SIDMOUTH STREET
LONDON

ARBORICULTURAL
METHOD
STATEMENT

PREPARED BY
ACD
ARBORICULTURE

FOR
CREST NICHOLSON

APPENDIX 1: CBA TREE PROTECTION PLAN MARKUP

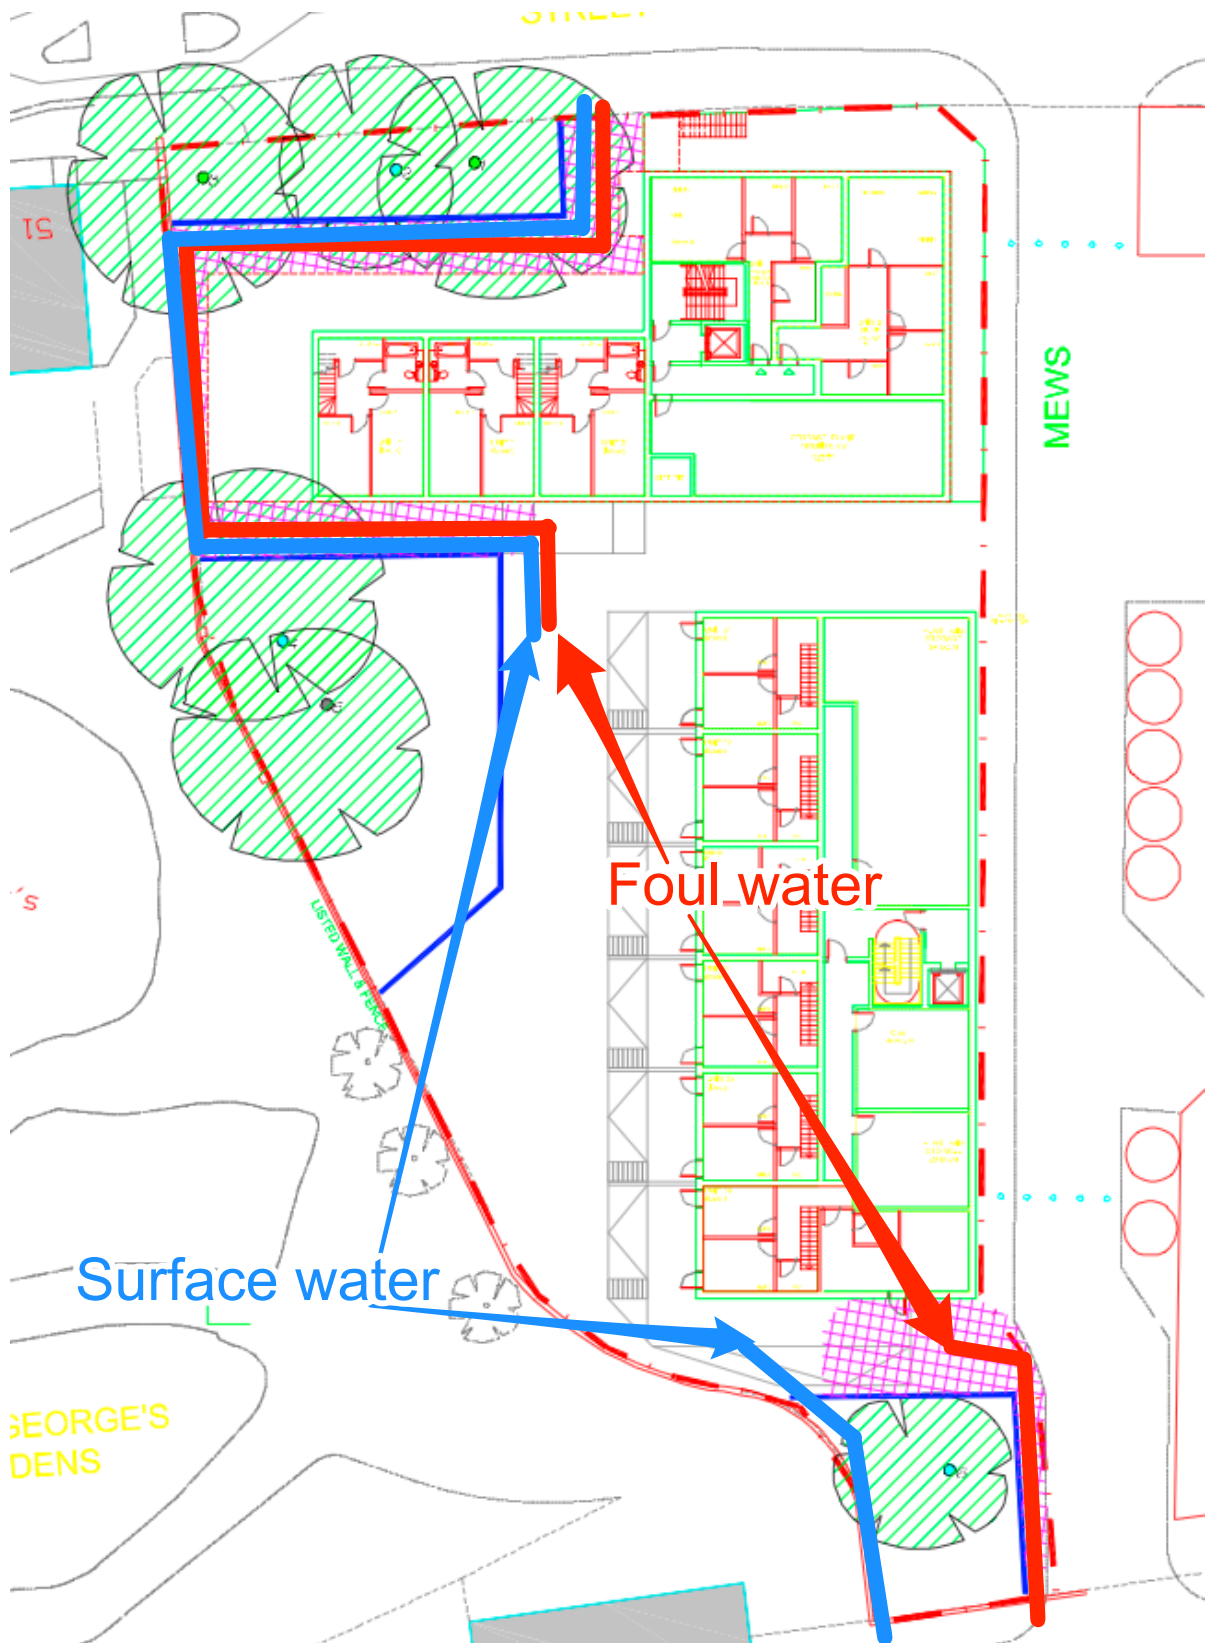
- 3.3. Given the nature of the site, and the need to install the drainage, ACD visited site and carried out some investigation into the underlying ground and rooting environment (photos appended). It was found, through digging a trial pit, that there was no development of any visible roots in the underlying strata and that therefore the ground protection was not required, and there would be no impact upon the trees if the services were run through the route shown on the appended plan. The hoarding contractor who was also excavating in the same area supported the

- 3.4. Therefore it is proposed that the ground protection (both areas shown on CBA documents) is redundant and not necessary for the successful retention of the trees.
- 3.5. The service routing shown on the plan for the northern section of the site, off Sidmouth Street, will then be installed in the margin between the building and the approved tree protection fence line. This approach will not result in any detriment to the large retained trees.
- 3.6. The tree on the southern section of the site, adjacent to Heathcote Road, is in similar situation although there is slightly more soft landscape immediately around the trunk. In this instance the proposed fence line will suffice and again, the ground protection is not required and shall be omitted. The foul and surface water trenches shall be dug hard up against either boundary (as shown on appended plan)
